NUCLEAR ENERGY INSTITUTE

**Subject:** Industry Guidance for Addressing Fatigue Environmental Effects in a License Renewal Application

## Summary of Revisions to MRP-47

### *Guidelines for Addressing Fatigue Environmental Effects in a License Renewal Application (MRP-47) Draft Revision G, 06/05/01*

Figure A-1. Environmental Correction Factor in NUREG/CR-6260 Compared to NUREG/CR-5704 Recommendation for Stainless Steel

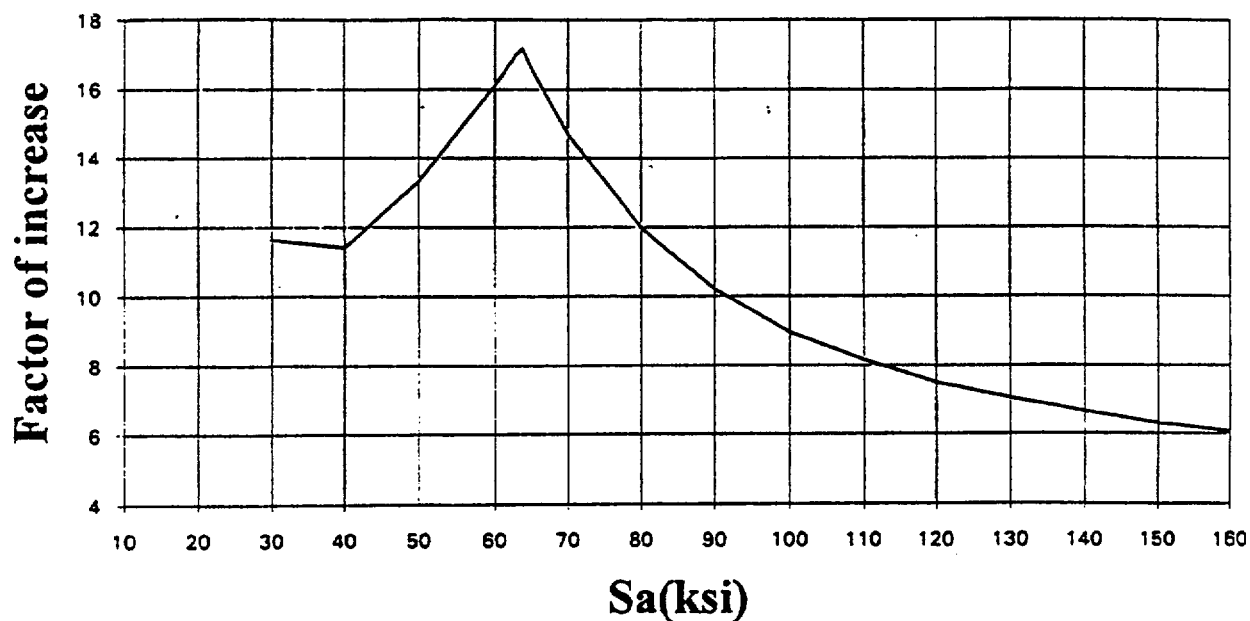
2. Reference 12, Page 3-11: The use of Reference 12 was incorrect. The method for determining strain-rate averaging has been explicitly defined.
3. Appendix A: A qualifier was added stating that the conclusions in this appendix would have to be justified for each specific plant. In Table 1, a note was added stating that the table might not be applicable to BWRs that has implemented hydrogen water chemistry.
